Access Compliance Report Public Rights-of-Way (Curb Ramps)

Main Street: BARACA_DR		Cross Street: AIROSO_ST		Location:	NW
ADA ID: RPRK211201143034	Ramp Type: Type 3 - Combination 1	Initial Pass/Fail: Fail	Overall Compliance: No	Severity Score:	32

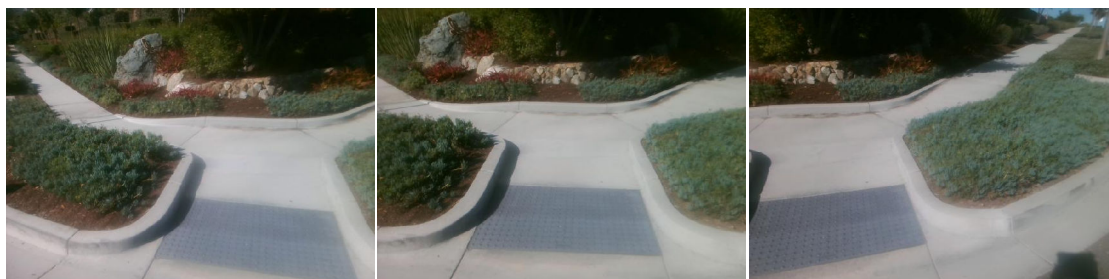
R304.5.3, R304.3.2, STD 1115

Remove & Replace Curb Ramp With Two New Directional Ramps or Equivalent.
